1CAN071501

SUBJECT: 90-Day Response to Request for Additional Information
Adoption of National Fire Protection Association Standard NFPA-805
Arkansas Nuclear One, Unit 1
Docket No. 50-313
License No. DPR-51

**90-day Responses to Request for Additional Information
ANO-1 Transition to NFPA-805**

Figure 1 – Input parameter variance on the CDF evaluation

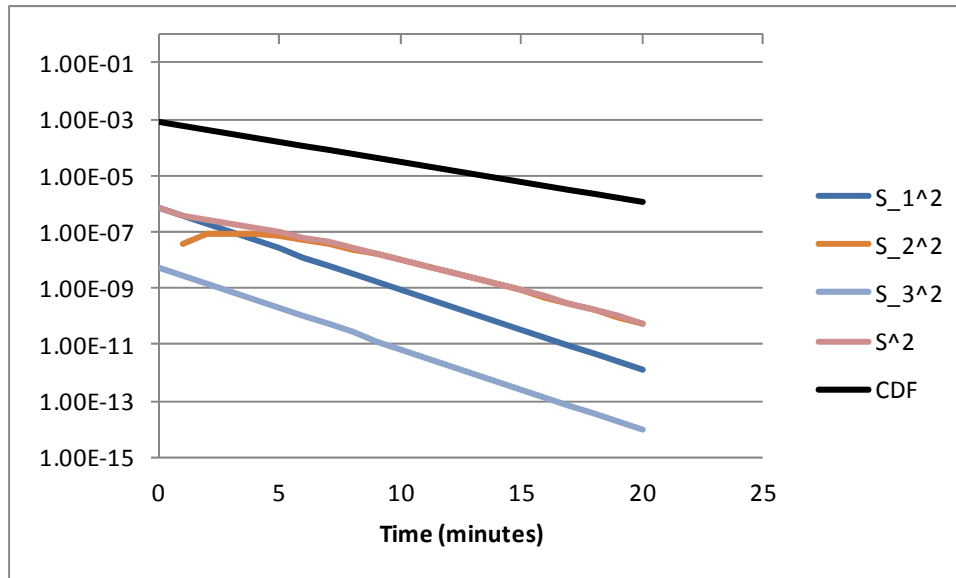
- p) Regarding the sensitivity analysis:
- (i) A baseline fire scenario is considered insensitive if the change in the total probability of control room abandonment remains less than 15 percent. Please provide technical justification for the 15 percent criterion.
 - (ii) The sensitivity analysis appears to indicate that raising the fire base to 1.2 m or 2.4 m significantly reduces the abandonment times for scenarios without operating HVAC. Please explain why the baseline scenarios were not updated to include the higher fire elevations.

- p)(i) The selection of fifteen percent criterion for model sensitivity to input parameter uncertainty is justified based on several considerations of the MCR abandonment application. The first consideration is that the process used to incorporate the parameter sensitivity into the baseline assumptions is conservative. This can be demonstrated by describing the process in more detail. The second consideration is that the fire modeling results of MCR abandonment are simply used as an input in a larger PRA model that includes various parameters with accepted levels of uncertainty. Given that the PRA model contains a significant amount of uncertainty, it can be shown that the additional uncertainty contributed by the assumed 15 percent threshold is insignificant. These factors taken together justify the selection of 15 percent model sensitivity to input parameter uncertainty.

Figure 1 shows that the total variance attributable to the uncertainty in the time to abandonment is approximately two to four orders of magnitude smaller than the total variance. This means that the contribution to uncertainty of CDF is completely dominated by the uncertainty in λ_g and λ and that the assumed uncertainty of fifteen percent in the parameter t is negligible by comparison. For example, the assumed uncertainty in the parameter t could be ten times greater than what is currently assumed without having an adverse impact on the total uncertainty in the PRA.
